PLANNING COMMISSION REPORT
Regular Agenda – Non-Public Hearing Item

PC Staff Report
PP-15-00067

ITEM NO. 3: PRELIMINARY PLAT FOR DREAM HAVEN; 2910 PETERSON RD (MKM)

PP-15-00067: Consider a Preliminary Plat for Dream Haven, a 7 lot residential subdivision containing approximately 9.3 acres, located at 2910 Peterson Road and adjacent parcels, and associated variances from the lot design and right-of-way width requirements in Section 20-810 of the Subdivision Regulations. Submitted by Treanor Architects, for David A. and Anne K. Gnojek and Dream Haven II LLC, property owners of record.

Figure 3. Right-of-way for Peterson Rd is consistent at 100 ft from Kasold Drive to N Iowa Street, with exception of unplatted property south of subject property (highlighted).

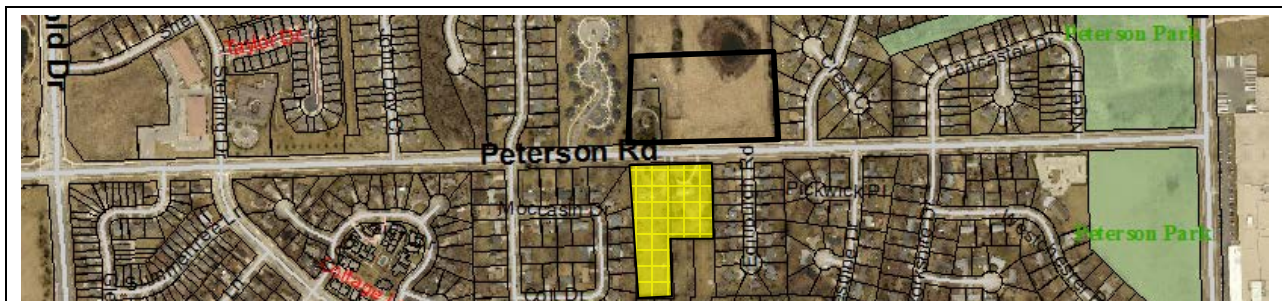
Variance from the 150 ft right-of-way width requirement in Section 20-810(e)(5)(i) for a Principal Arterial to allow the right-of-way for Peterson Road to remain at 100 ft (50 ft from centerline) for that portion of Peterson Road adjacent to the subject property.

The right-of-way width is consistent at 100 ft from Kasold Drive on the west to N. Iowa Street on the east. This area has been platted and developed with the exception of the subject property and the property just to the south of the subject property. (Figure 3) When this property is platted, it will be required to provide the additional right-of-way to match the existing right-of-way in the area.

The 150 ft right-of-way standard is intended primarily for green field development, rather than infill; however, additional right-of-way is often required to accommodate future street improvements. Peterson Road was recently improved and the City Engineer indicated there were no plans to widen it in the future. Dedicating the additional right-of-way would remove property from the developable area and would reduce the area the applicant has designated as open space.

Staff Finding: As the right-of-way is not needed for future street improvements, requiring the dedication for the subject property would be an unnecessary hardship on the applicant.

Approve the variance requested from Section 20-810(e)(5)(i) from the requirement to dedicate additional right-of-way for Peterson Road adjacent to this subdivision subject to the following condition:

The plat shall be revised to note that a variance from the right-of-way width required in Section 20-810(e)(5) of the Subdivision Regulations was granted by the Planning Commission to allow the right-of-way on the subject property side of the center line to remain at 50 ft and list the date of approval.

Figure 4. Frontage proposed for Lots 2 and 3.

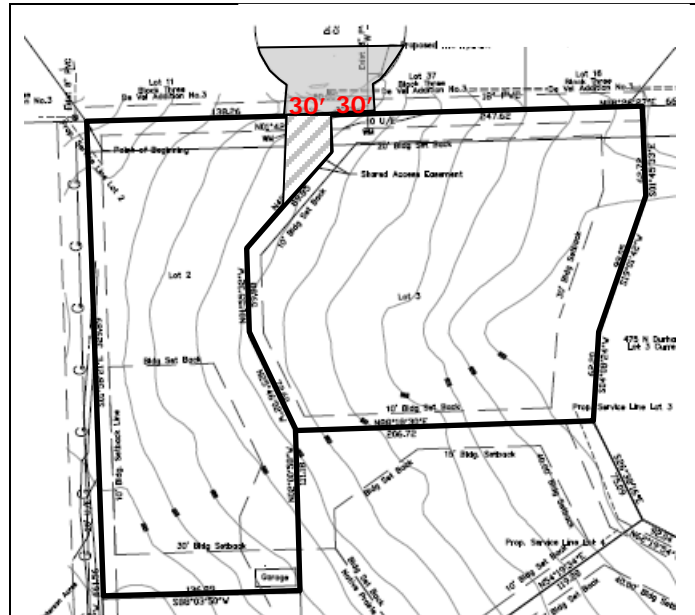
Variance from the requirement in Section 20-810(a)(2)(i) of the Development Code that all lots comply with the dimensional requirements of the zoning district to allow the creation of 2 lots, Lots 2 and 3, with less than the 40 ft lot frontage required in the RS7 Zoning District. Lots 2 and 3 will divide the 60 ft of frontage available for Durham Court and will have 30 ft of frontage each. (Figure 4)

Durham Court terminates in a cul-de-sac with a stub that extends to the subject property's north boundary. It would not be possible to extend Durham Court to the south to provide each lot with the required frontage due to the code restrictions on the lengths of cul-de-sac. The Durham Court cul-de-sac is currently approximately 786 ft long. Per Section 20-810(e)(8)(1) of the Development Code a cul-de-sac may have a maximum length of 1,000 ft or 10 times the required minimum lot width of the zoning district, whichever is less. The RS7 District requires a minimum lot width of 60 ft so the maximum cul-de-sac length permitted would be 600 ft. Extending the street would require either a variance from the maximum cul-de-sac length or the continuing the extension to the south to connect with Peterson Road. This would require the construction of approximately 640 ft of street and would alter the character of the subject property. It would require the property to be developed in a more conventional pattern rather than the low density pattern that is proposed.

40 ft of frontage is required on a cul-de-sac to insure adequate width for a driveway. The 2 lots being proposed will utilize a shared access so one driveway will be provided on the 60 ft of frontage.

Staff Finding: While Lots 2 and 3 will have less than the required 40 ft of frontage per lot, they will have a combined frontage of 60 ft and will utilize a shared driveway. Lots 2 and 3 could have the required 40 ft of frontage only if Durham Court were extended. Due to the length restrictions on cul-de-sacs, Durham Court would need to be extended to connect to Peterson Road which would alter the large lot/open space character of the development. This would be an unnecessary hardship upon the subdivider.

Approve the variance requested from Section 20-810(a)(2)(i) of the Subdivision Regulations to allow the creation of Lots 2 and 3 with 30 ft of frontage, rather than the 40 ft required by Code subject to the following conditions:

The plat shall be revised to note that a variance from the Lot design requirement in Section 20-810(a)(2)(i) of the Subdivision Regulations was granted by the Planning Commission to allow the creation of 2 lots with 30 ft of frontage on Durham Court provided the lots utilize a shared access.

PRELIMINARY PLAT
DREAM HAVEN II
REPLAT OF "DREAM HAVEN" LOTS 1, 2, and 3. A SUBDIVISION OF LAND IN
LAWRENCE, DOUGLAS COUNTY, KANSAS.

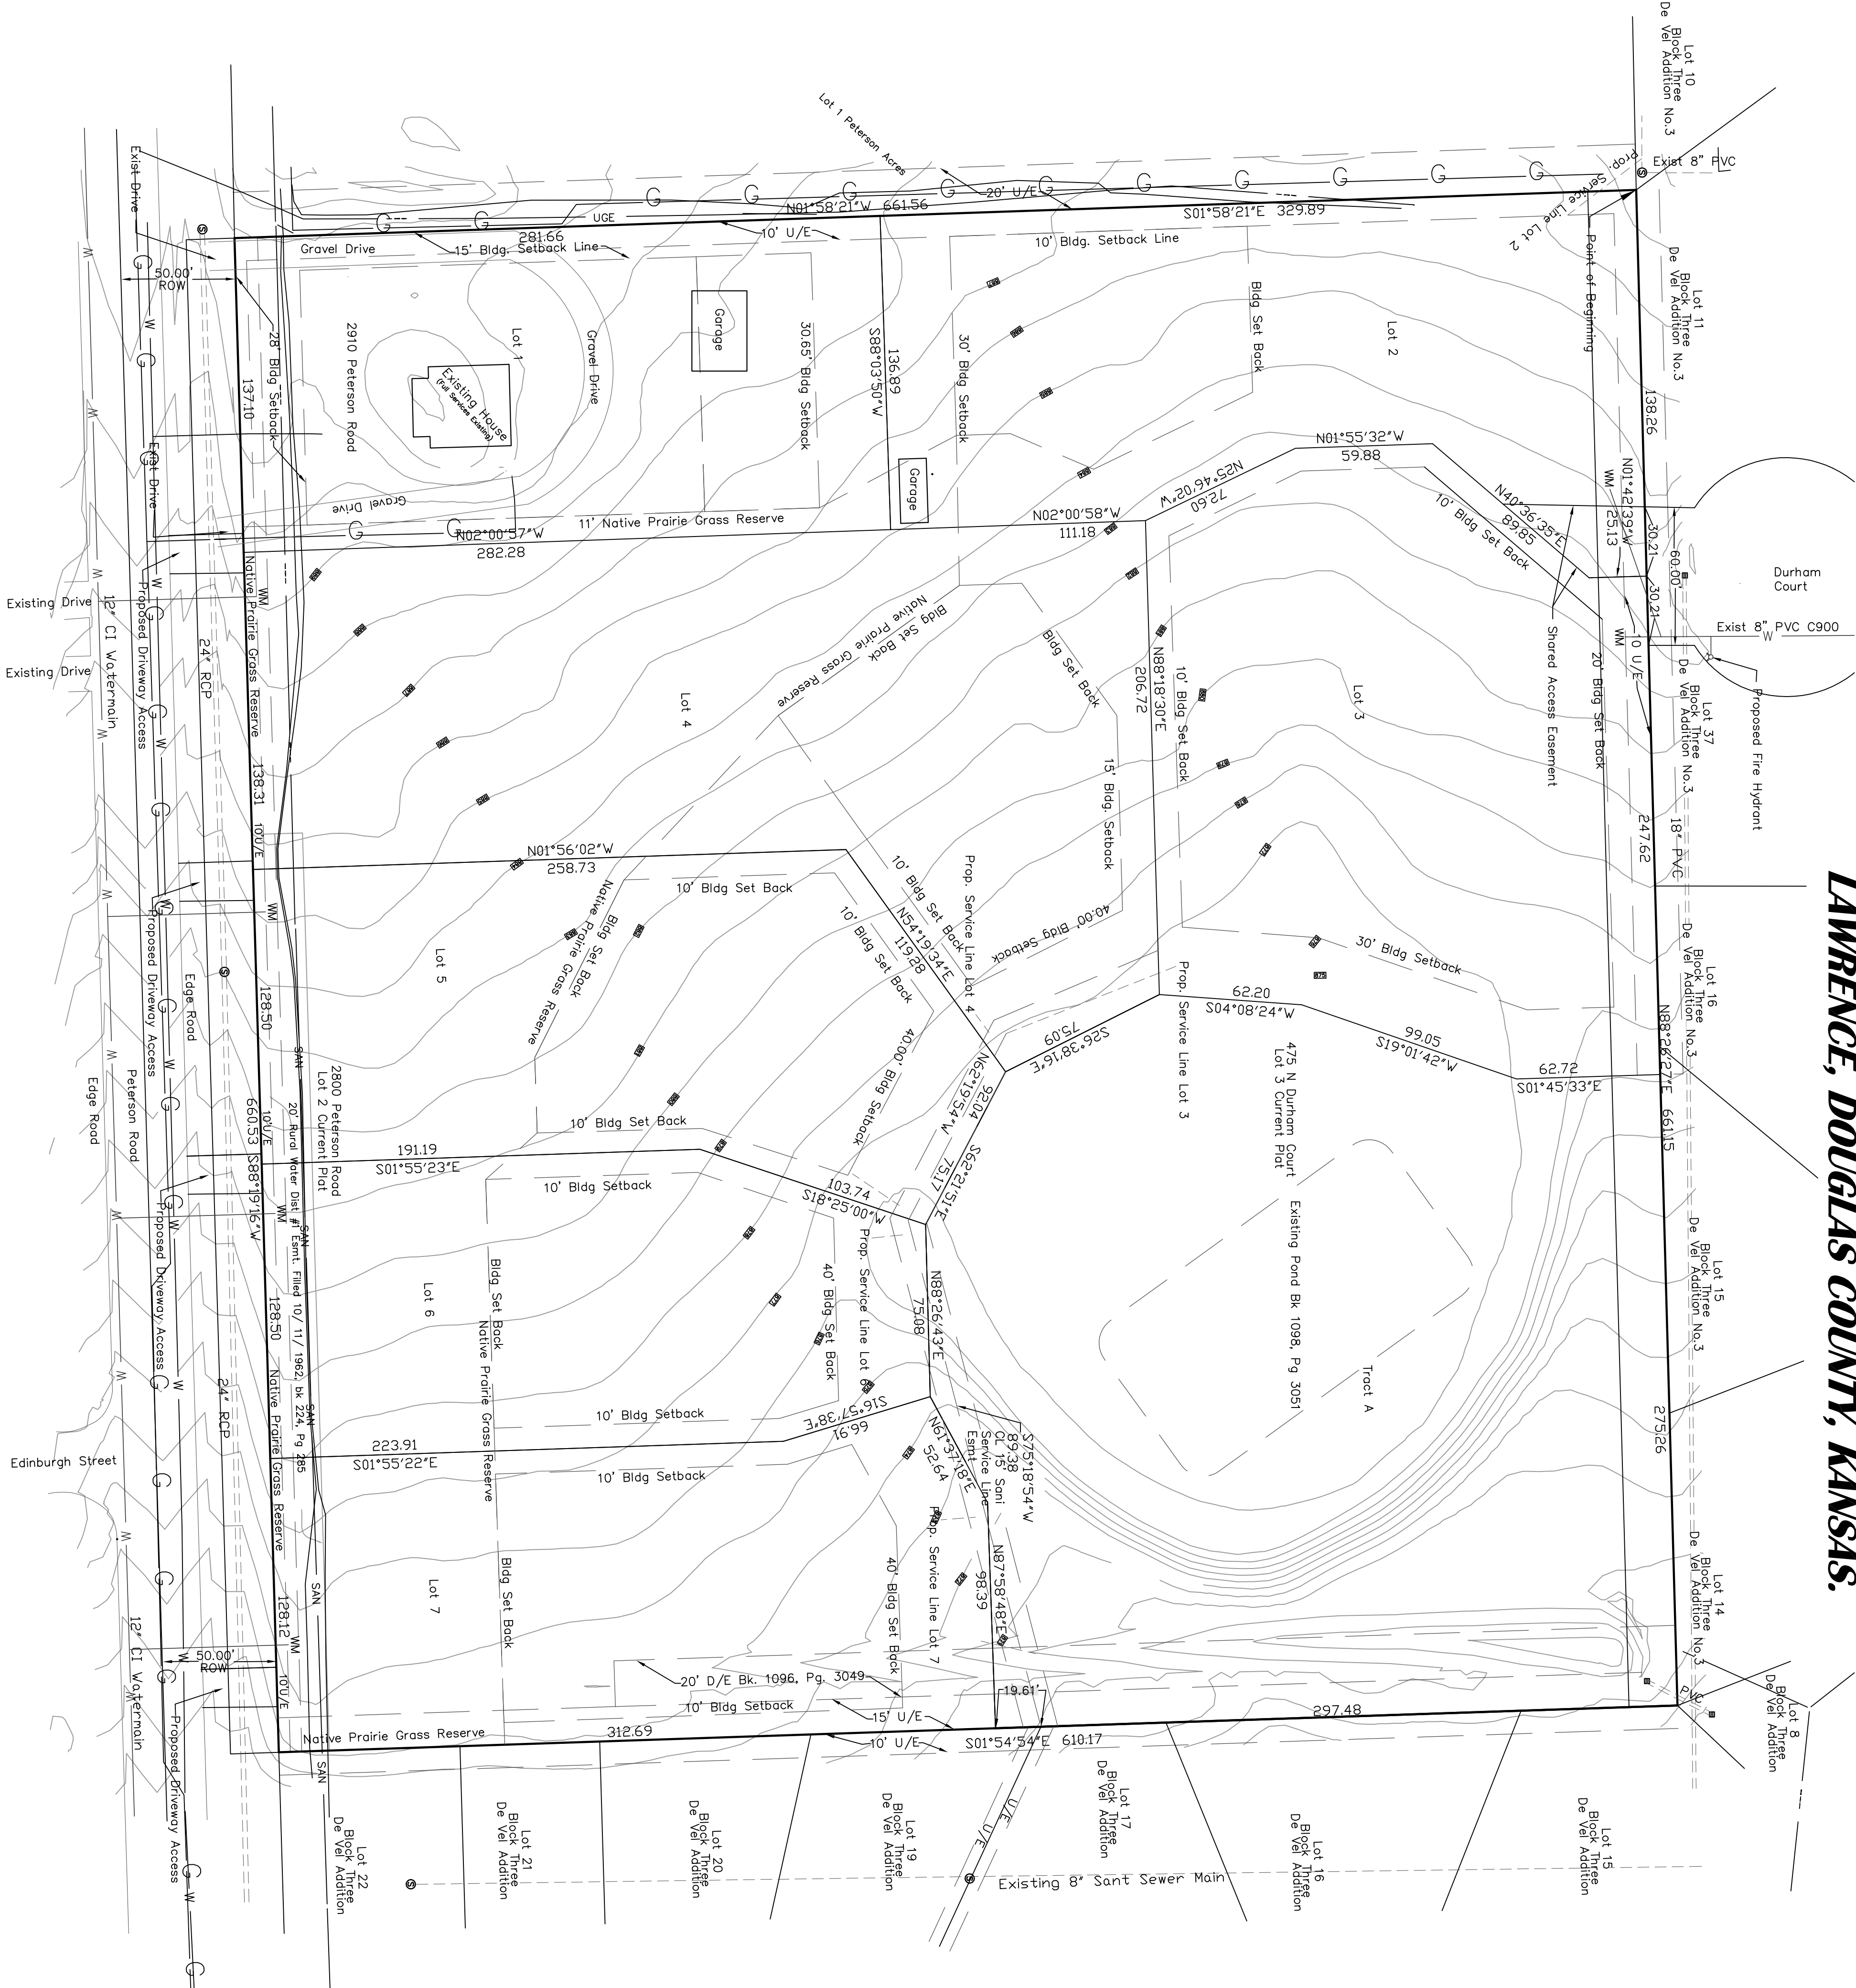
1. Provision of a drainage study/dam rehab plan and Downstream Sanitary Sewer Analysis per City approval.
2. Applicant shall provide a revised preliminary plat with the following changes:
 - a. Access points on Peterson Road revised per the City Engineer's approval.
 - b. Sewer mains extended to touch each lot, per City Utility Division approval.
 - c. Addition of notes reflecting any variances that are approved.

As noted earlier, the plat includes building envelopes with extraordinary setbacks to prevent intrusion into the area along Peterson Road where native prairie grasses will be established. (Figure 2) The building envelopes include a larger setback from Peterson Road than the 25 ft setback that is required with the RS7 Zoning. This open space area will be planted with native prairie grasses and excluding it from the building envelope will insure it is not developed, with the exception of the access drives. The ownership and maintenance responsibility of the tract should be noted on the plat.

The property contains a pond which will be used for stormwater management. The City Stormwater Engineer indicated that the dam was in need of repair and that a rehabilitation plan should be included with the drainage study.

The plat shall be revised to note that a variance from the right-of-way width required in Section 20-810(e)(5) of the Subdivision Regulations was granted by the Planning Commission to allow the right-of-way on the subject property side of the center line to remain at 50 ft and list the date of approval.

The plat shall be revised to note that a variance from the Lot design requirement in Section 20-810(a)(2)(i) of the Subdivision Regulations was granted by the Planning Commission to allow the creation of 2 lots with 30 ft of frontage on Durham Court provided the lots utilize a shared access.
